MINOR WORKS SUBCONTRACT ORDER NO. 201A22002/67
PROJECT NAME: Dorchester Hotel & Residences (Completion Works)

Dorchester Hotel & Residences
Supply fabrication & installation of Retractable Pergola Systems - Post Tender Meeting

KHANSAHEB CIVIL ENGINEERING LLC
SUBCONTRACTOR'S POST TENDER REVIEW MEETING

The Lana by Omniyat, Business Bay
Canopy Design, Level 10

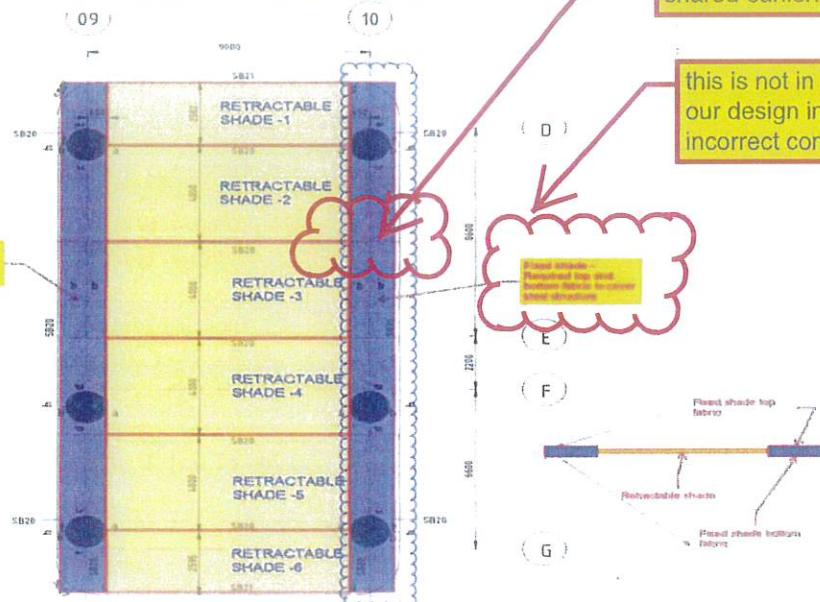
Fixed shade - Required top and bottom fabric to cover steel structure

no, fixed shade to follow same profile and no top and bottom fabric allowed

this is not in line with our design intent.
incorrect comment
